SUBJECT: **Addendum #04** – Bid# 22000047 – CWSRF Project Battery B Grit and Primary Settling Tanks

CITY OF FLINT, MICHIGAN
Water Pollution Control
Grit Battery B System and Primary Tank Improvements
Contract Number 200-156238-21001-S-1
SRF No. 5709-01

Addendum No. 4
July 20, 2021

D-101

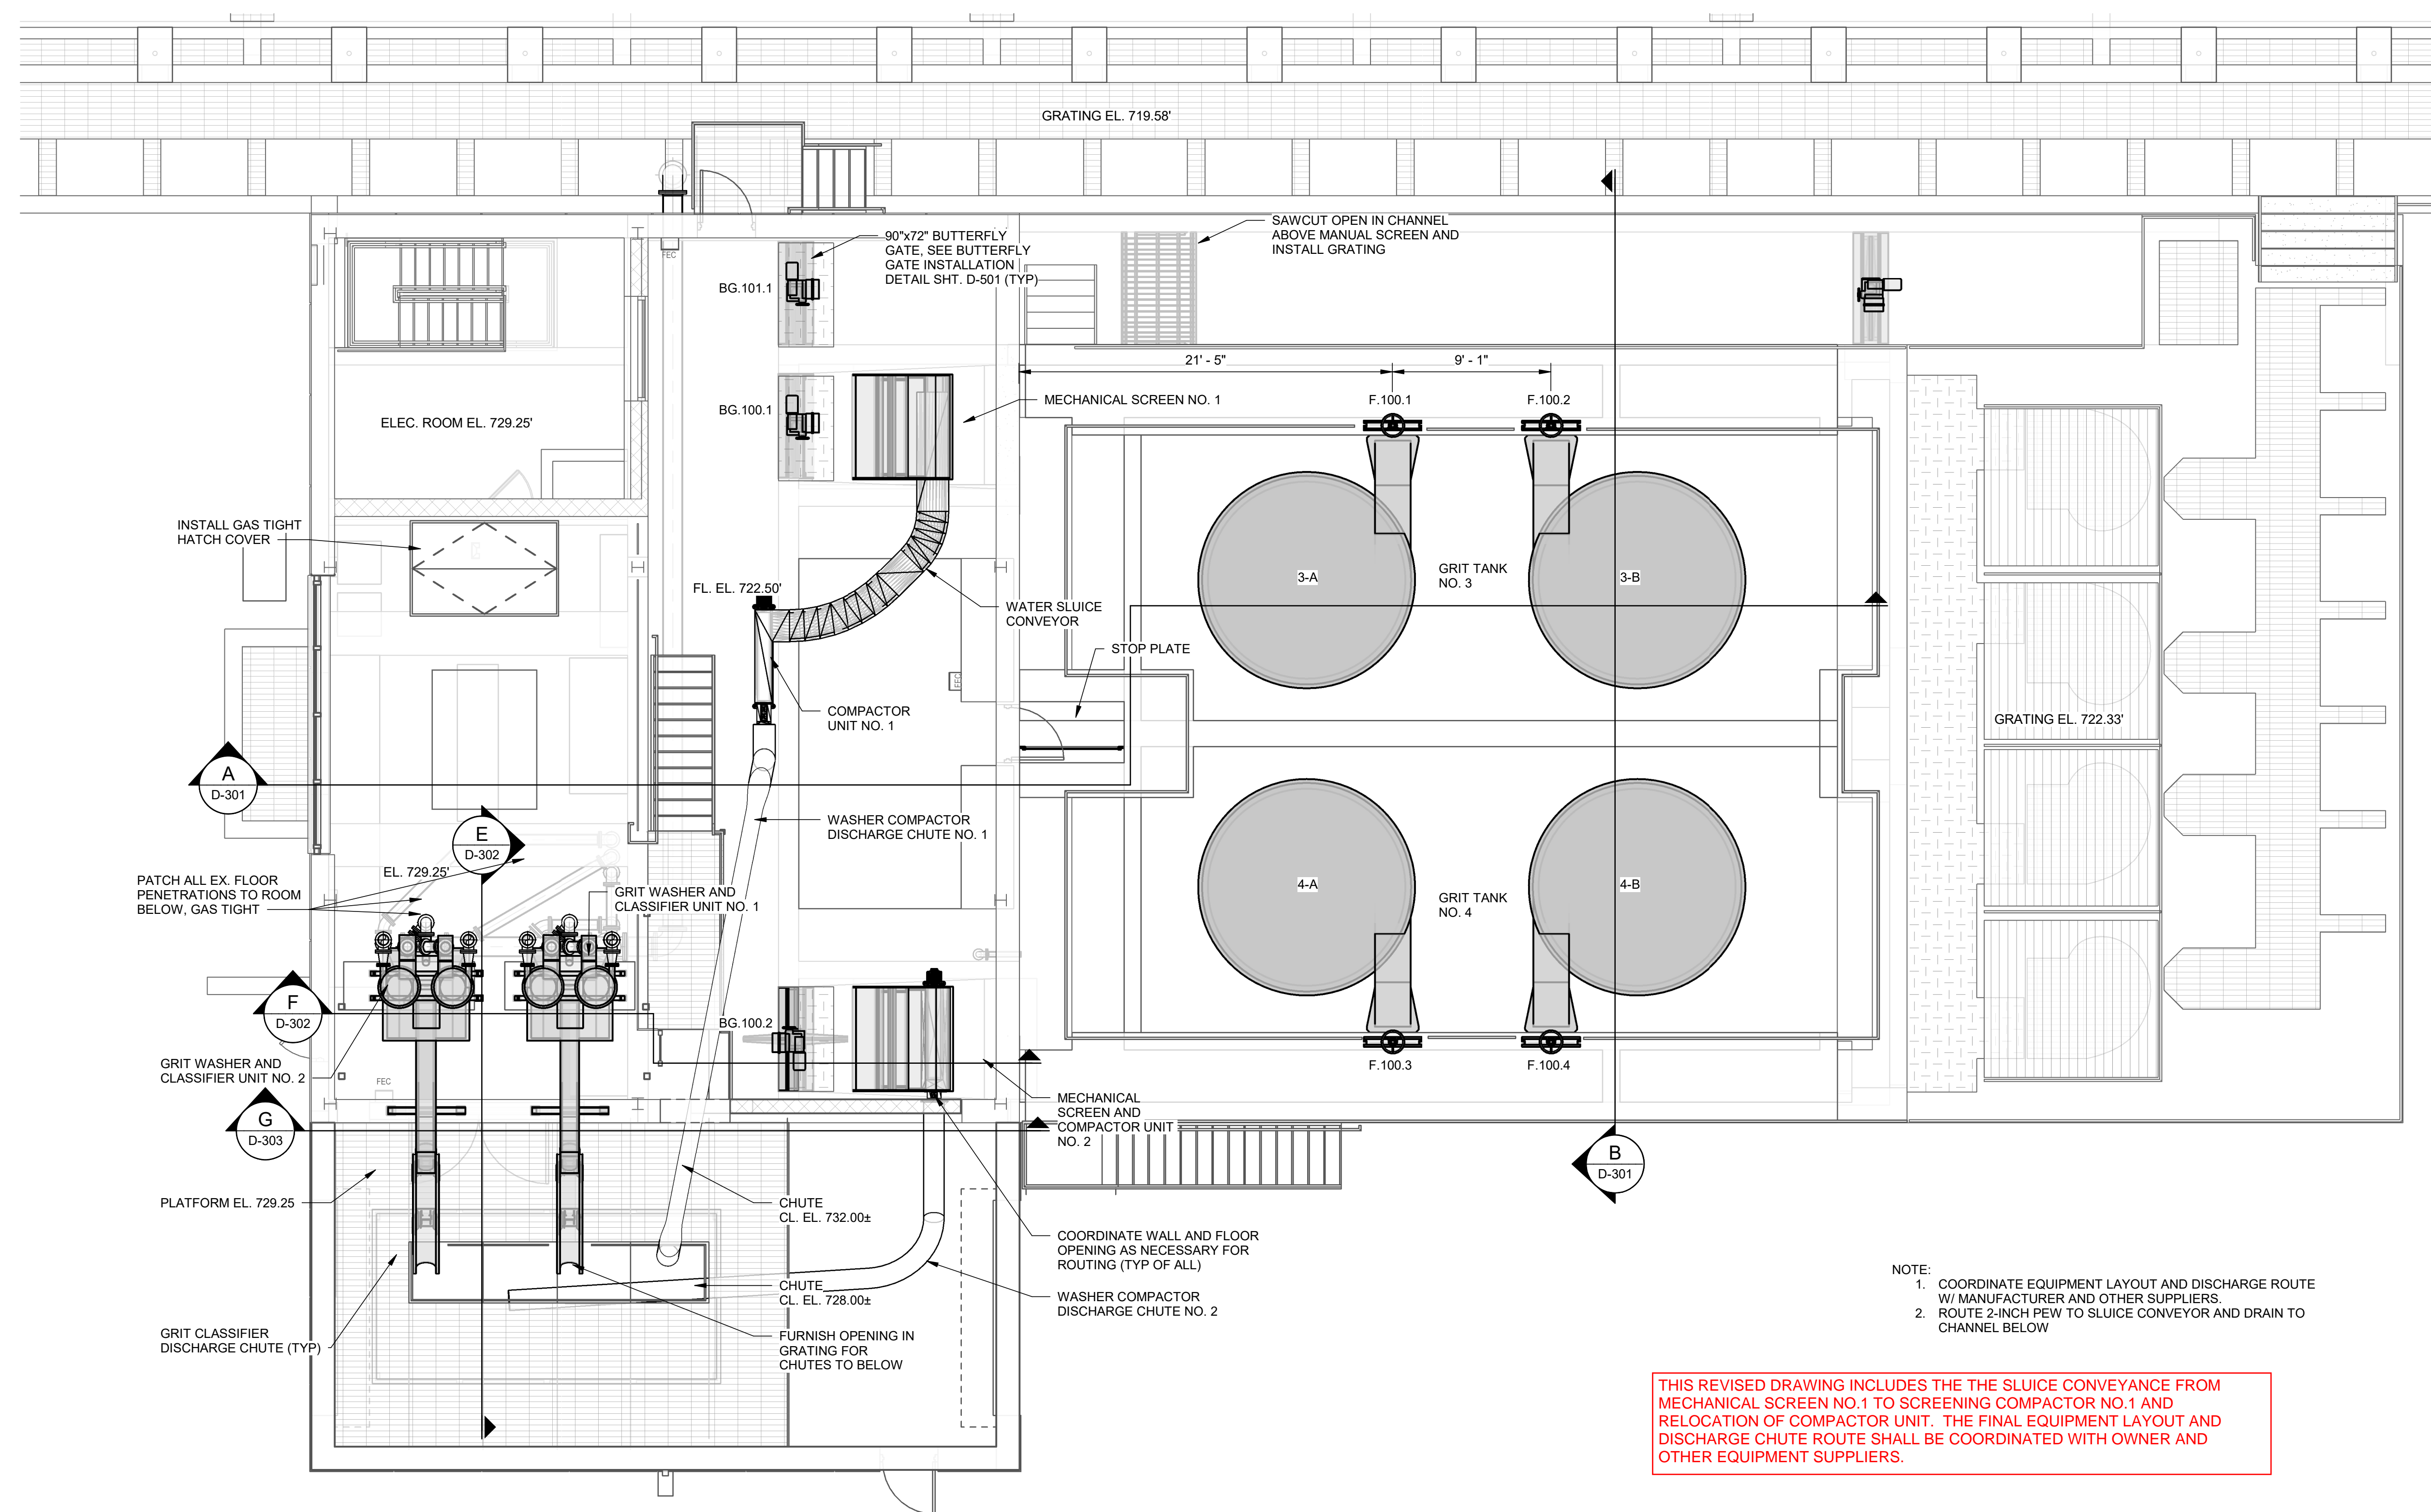
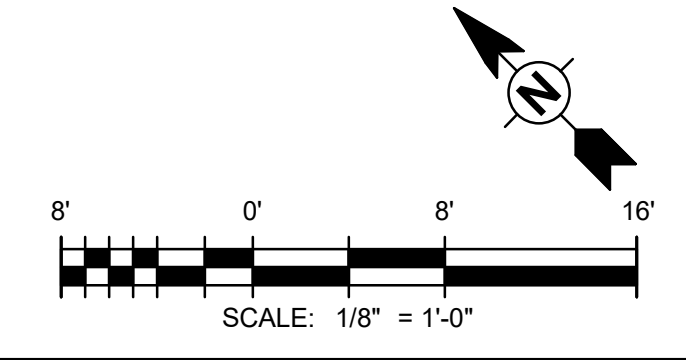
Sheet D-101, delete sheet and replace with D-101 included as part of Addendum No.4.

This drawing includes the addition of sluice conveyance from Mechanical Screen No. 1 to Screening Compactor No. 1 and relocation of compactor unit. The final layout of equipment shall be coordinated by Contractor with all equipment suppliers and Owner.

- NOTE:
- COORDINATE EQUIPMENT LAYOUT AND DISCHARGE ROUTE W/ MANUFACTURER AND OTHER SUPPLIERS.
 - ROUTE 2-INCH PEW TO SLUICE CONVEYOR AND DRAIN TO CHANNEL BELOW

THIS REVISED DRAWING INCLUDES THE THE SLUICE CONVEYANCE FROM MECHANICAL SCREEN NO.1 TO SCREENING COMPACTOR NO.1 AND RELOCATION OF COMPACTOR UNIT. THE FINAL EQUIPMENT LAYOUT AND DISCHARGE CHUTE ROUTE SHALL BE COORDINATED WITH OWNER AND OTHER EQUIPMENT SUPPLIERS.
